# DEFENSE NUCLEAR FACILITIES SAFETY BOARD

**SUBJECT:** Report on the Radiation Protection Program at the Hanford Site

1. **Purpose:** This memorandum documents the Defense Nuclear Facilities Safety Board (DNFSB) technical staff and outside expert assessment of the Radiation Protection Program at the Hanford Site. This assessment is based on an on-site review at Hanford conducted on October 18-21, 1993, and subsequent document reviews and discussions.

Figure 1

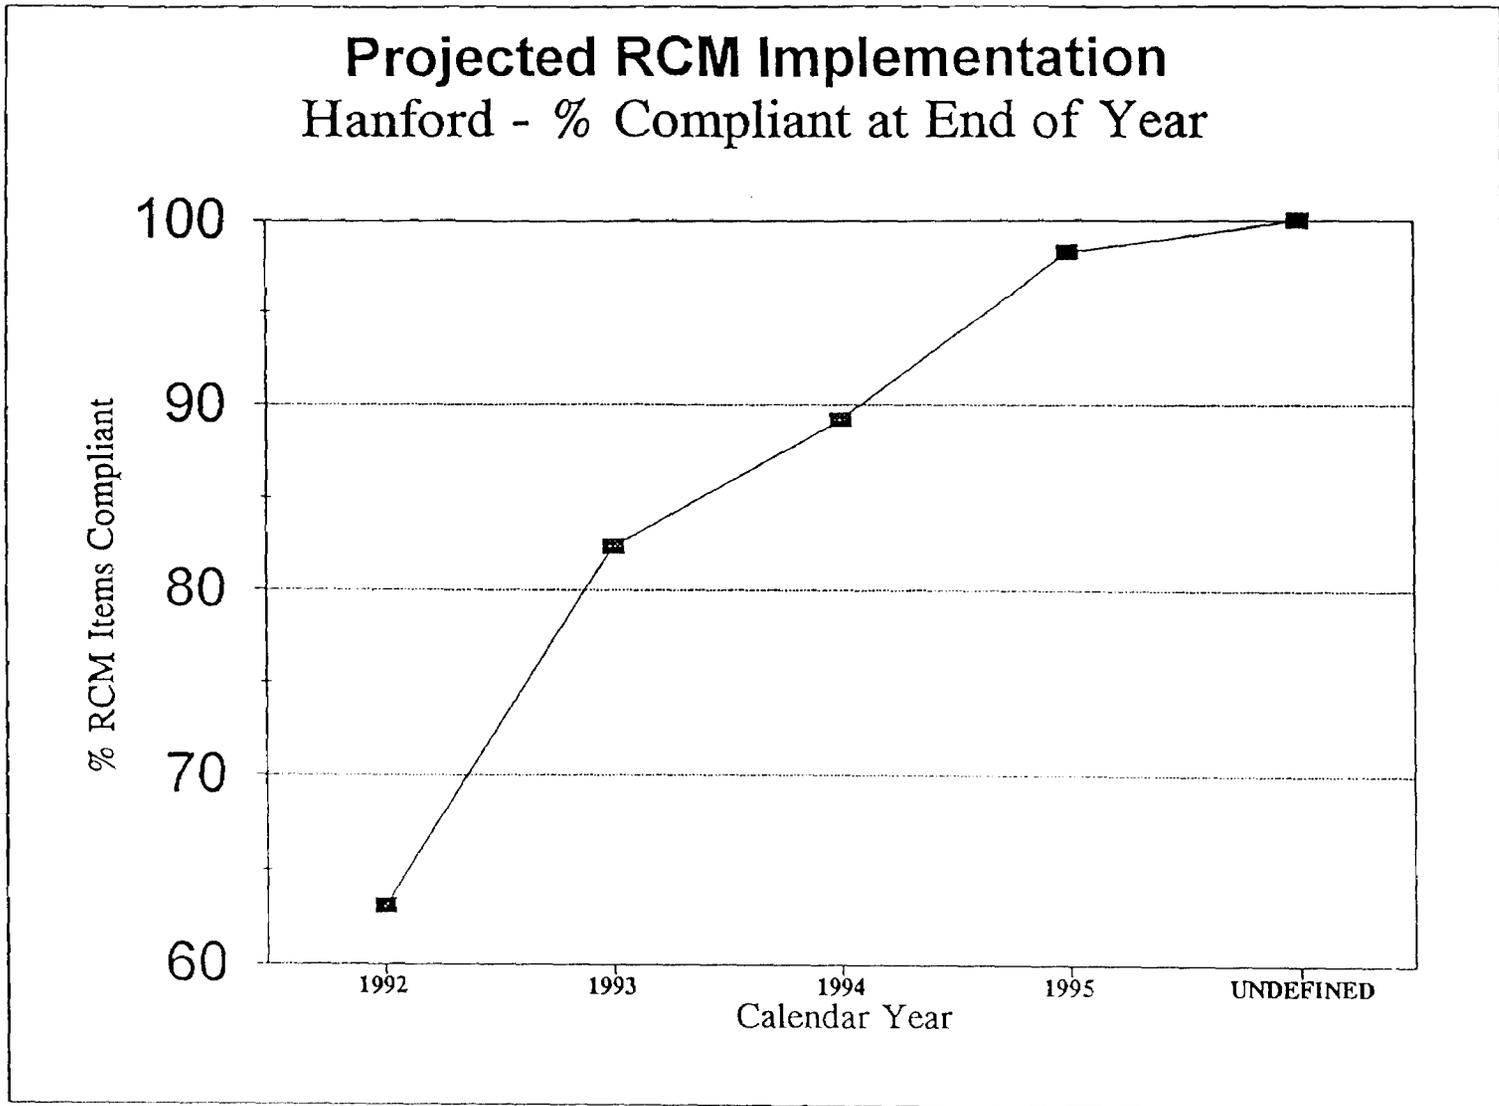
- a. Hanford Site contractors are working towards implementing the requirements of the DOE Radiological Control Manual (RCM), and are projected to be 82.3% in compliance at the end of calendar year 1993, and with the exception of Articles 221, 421, and 422 will be fully compliant by April 1995 (refer to Figure 1)<sup>1</sup>. Several of the Hanford RCM implementation plan's compliance assessments were found to be incomplete or inaccurate, and some assessments did not give sufficient technical justification for compensatory actions. Overall, the Hanford Site plan to accomplish RCM training is consistent with the DOE Implementation Plan for DNFSB Recommendation 91-6.
